City of Oregon City

Meeting Agenda Historic Review Board

Tuesday, April 28, 2020

3a. GLUA-20-00009 and HR 20-05: Historic Review For a New Detached Garage in the McLoughlin Conservation District at 420 4th Street.

Option 1 10-foot setback.

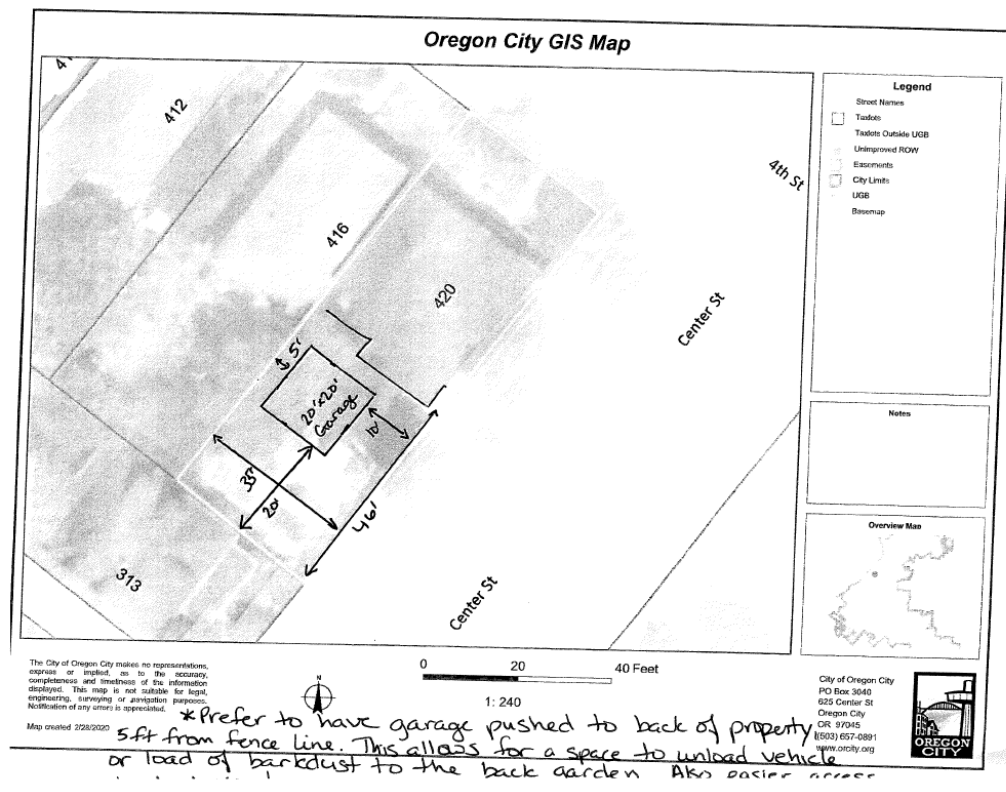
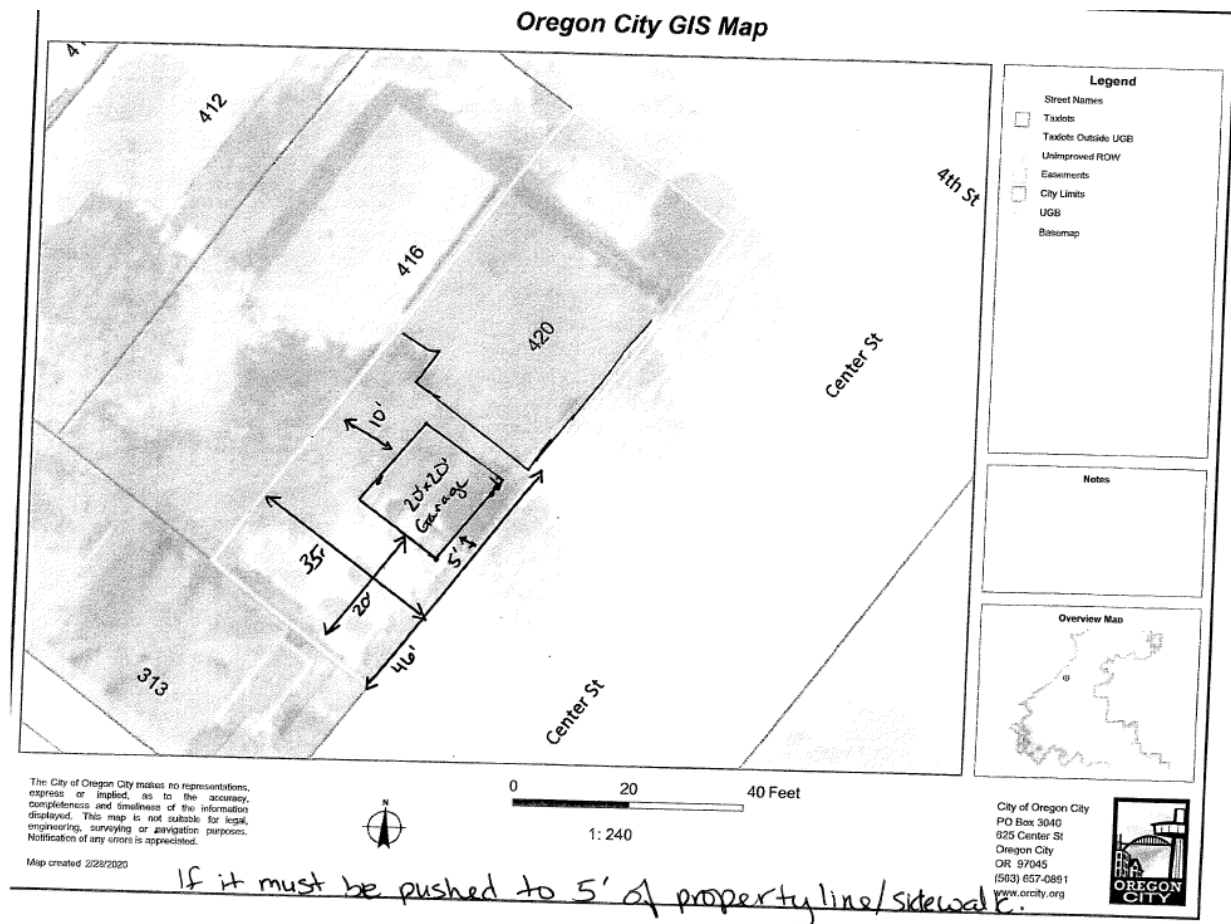
A preservation incentive to reduce setbacks is needed, but it was not initially requested. Since a preservation incentive was not requested at the time of application, the application was continued from the originally scheduled hearing of February 26, 2020 to March 24, 2020 to allow time to re-notice the application. The Applicant submitted a site plan proposing two options for the garage with 1. A 10-foot setback from Center Street and 2. A 5-foot setback from Center Street.

Josh Wheeler, Assistant City Engineer, provided comment that a 10-foot corner side garage setback did not provide enough space for a car to safely park in the driveway without blocking pedestrian traffic. He did not support the 10-foot setback option. He felt that the 5-foot option would not create a situation that encourages cars to park in the driveway. While the Applicant indicated that she would not park in the driveway for either option, there is no way to enforce that requirement if the property is sold. John Replinger, the City's Traffic Engineer, found that traffic volumes were slow enough to allow either option to be built. Garages in the Mcloughlin Conservation District were historically located near the street, and either setback option is appropriate for a detached corner side garage.

Finding: Complies with Condition. A preservation incentive to reduce setbacks is needed, but it was not initially requested. Since a preservation incentive was not requested at the time of application, the application was continued from the originally scheduled hearing of February 26, 2020 to March 24, 2020 to allow time to re-notice the application. The Applicant submitted a site plan proposing two options for the garage with 1. A 10-foot setback from Center Street and 2. A 5-foot setback from Center Street.

Site Plan (Revised – March 2020 Plans)

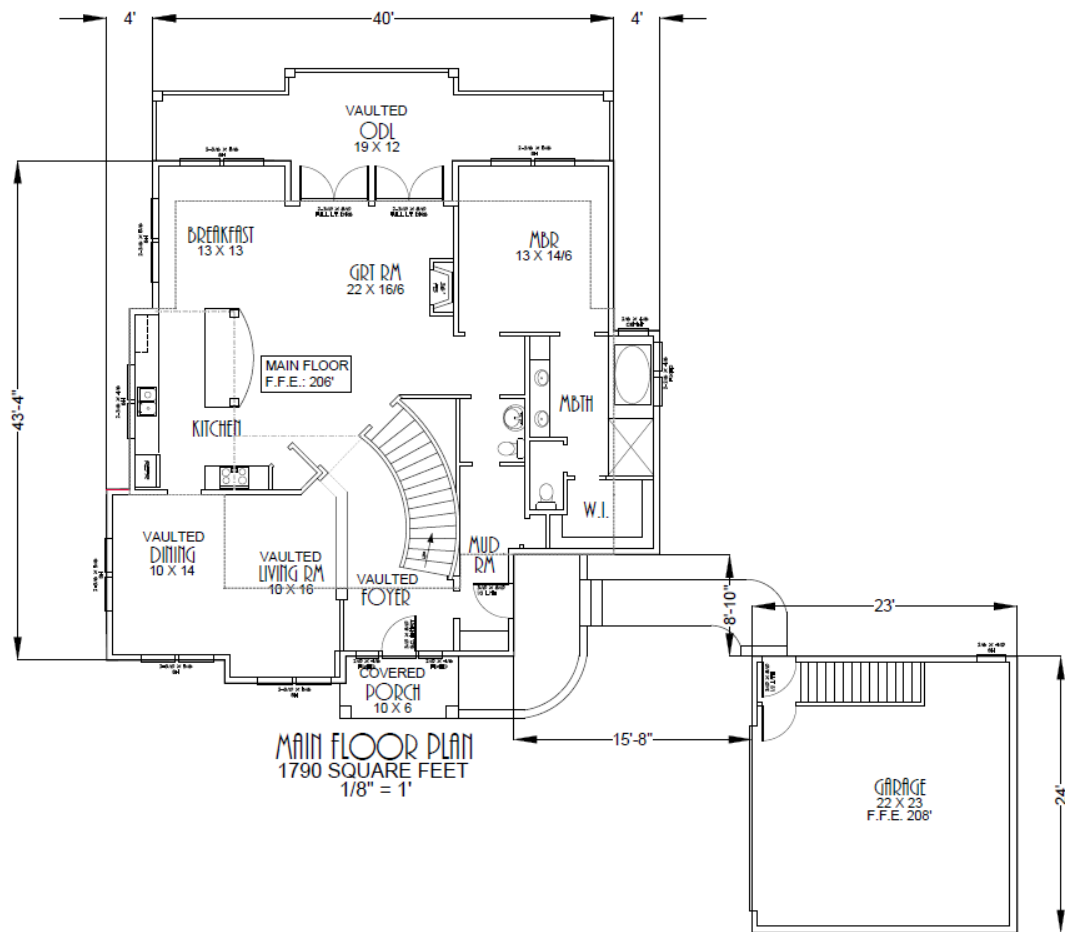
Staff recommends that the Historic Review Board conditionally approve GLUA-20-00007/HR 20-04 if the applicant revises the plans to demonstrate a maximum width of 37 feet at grade.

The Applicant submitted a letter on March 10, indicating that they will reduce the width of the house. *"We got the response back requesting to revise the design to get the width down to less than 40 feet. We are compromising more and reducing the width by 6.5 feet as requested. Also, as recommended, we will be doing more screening, removing the sense of entrance from the 4th to make the appearance of a one and a half story bungalow."*

Staff contacted the applicant to see if they wished to continue the application to the April 27, 220 Historic Review Board Meeting. They chose not to and requested a decision from the Historic Review Board at the March 24, 2020 Historic Review Board Meeting. The March meeting was continued to April 28, 2020. On March 23, 2020, the applicant submitted revised plans with a reduced front porch width of 40 feet that widens out to 48 feet with bump outs on both side elevations. It appears that the West elevation (Corner Side yard-Hedges) is cantilevered and the East elevation (internal side yard) bump out is at grade. These revised plans can be found as an exhibit to the staff report.

Site Plan (Revised April 2020)

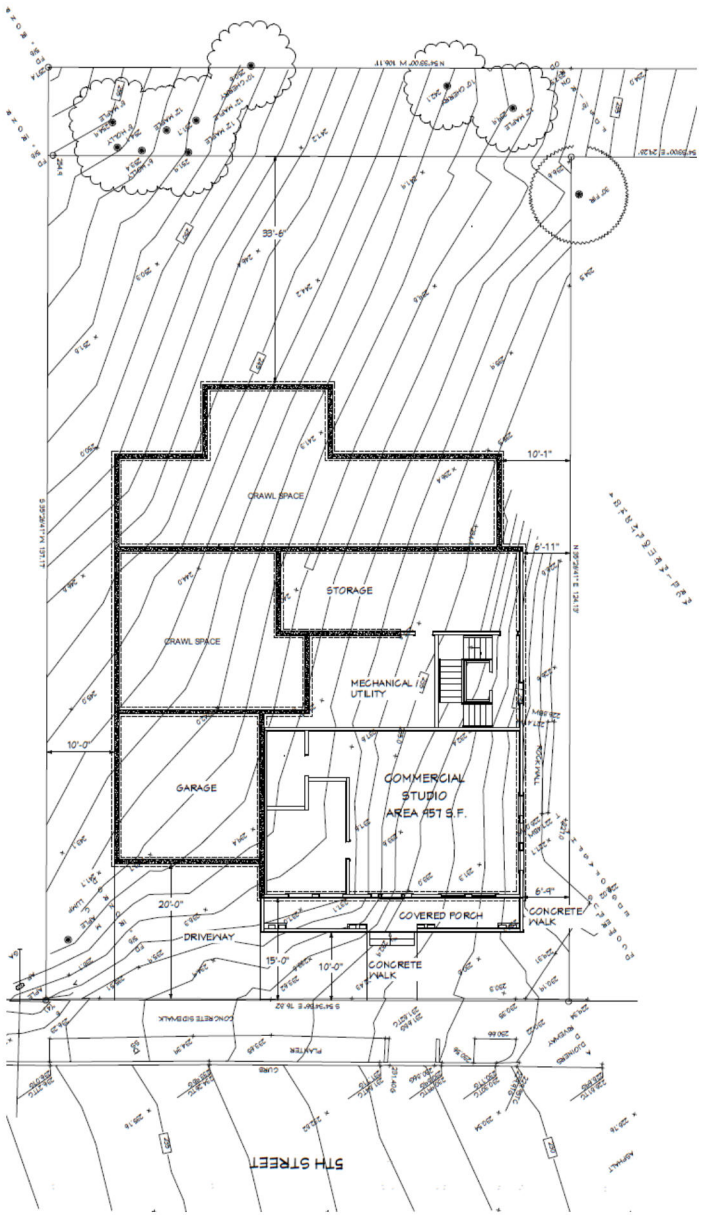
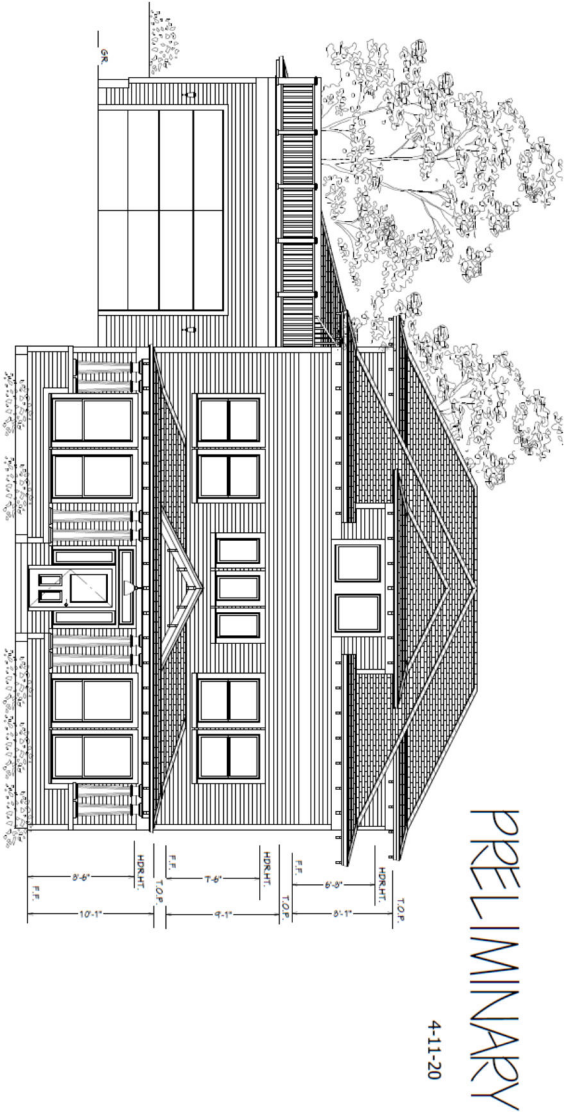
- The proposed mixed-use building is very large. The bulk, proportion and scale of the proposed building is out of scale with the adjacent structures and the neighborhood in general. The 5th Street corridor is primarily residential. The building as proposed is shown as having 9 bedrooms, 11 bathrooms, 3 laundries, and 3 kitchens. The building floorplan suggests a care facility, and the applicant indicated it may be used as such in the future. MNA feels the application should reflect the likely use of a care facility, as it may be problematic to modify it in the future to meet criteria for that use.

- The rear elevation of the proposed building lacks details - it is too modern, lacks relief, and does not match detailing on the front elevation.
- The proposed garage door is too large and the proposal should show two garage doors.

- The use includes a commercial space. The site plan does not allow space for trash receptacles, parking and maneuvering.
- The site plan does not depict proposed landscaping.
